PLANNING, ZONING, & BUILDING DEPARTMENT
PZ&B Staff Combination Memorandum: Architectural Commission and Town Council

SUBJECT: ARC-23-107 (ZON-23-077) 162 E INLET DR (COMBO)

MEETING: NOVEMBER 20, 2023

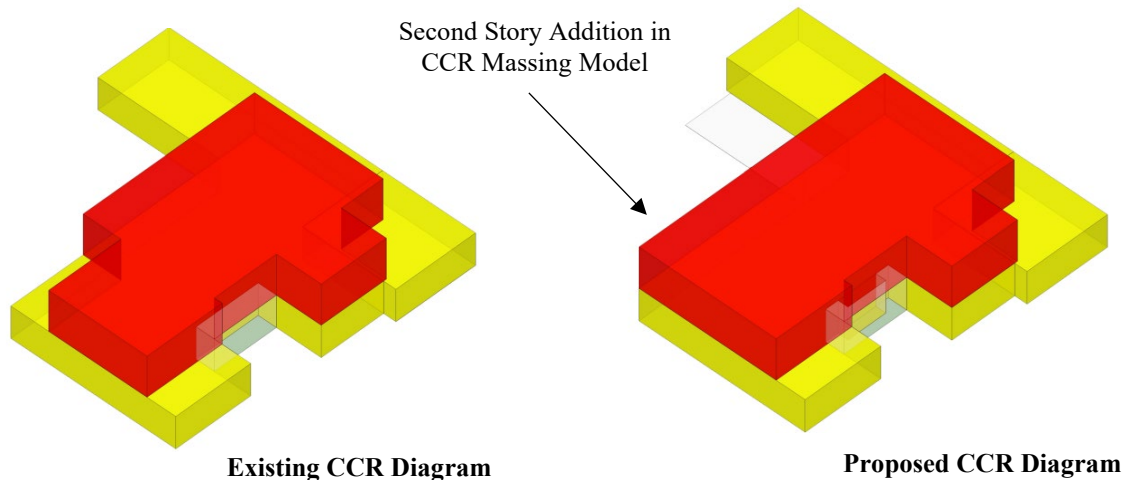
A preliminary review of the project indicates that the application, as proposed, is inconsistent with the Town zoning code and requires one (1) variance to increase the already non-conforming Cubic Content Ratio (CCR) beyond what code permits, the maximum of which for this sized (10,848 SF) R-B zoned lot is 3.99.

The two-story single-family residence at 162 E Inlet Drive was constructed ca. 2004 on a 10,848 SF parcel. The current application requests to construct two enclosed additions and a rear pergola over a patio. Additional modifications include window and door replacement and the

The applicant has made modifications to the project since the September meeting, including design alterations to the rear trellis, fenestration modifications to the rear façade, and roof and façade adjustments to the rear second story addition. The landscape and hardscape program remains as proposed at the September meeting.
